Amendments to the Drawings

Remarks/Arguments

Appl. No. 10/731,336 Amdt. Dated April 29, 2005 Reply to Office Action of February 10, 2005

FIG. 11 Prior Art

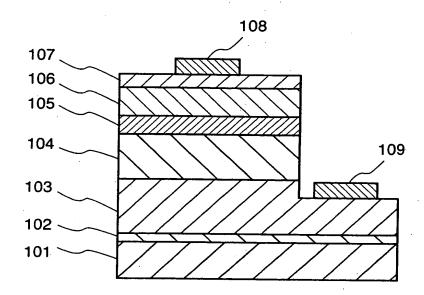
Figures 11 and 12 are objected to under MPEP 608.02(g) for lacking a legend such as "Prior Art". In response, Figures 11 and 12 are amended to include the legend "Prior Art". The drawings are further objected to under 37 CFR 1.84(p)(5) for lacking reference sign 110. In response, Figure 12 is amended to include reference sign 110. A replacement sheet with the corrections to Figures 11 and 12, and an annotated sheet showing the changes, are enclosed.

The attached sheet of drawings includes changes to Figs. 11 and 12. This sheet replaces the original sheet including Figs. 11 and 12. In Figs. 11 and 12, the legend "Prior Art" has been added. In Fig. 12, previously omitted reference sign 110 has been added.
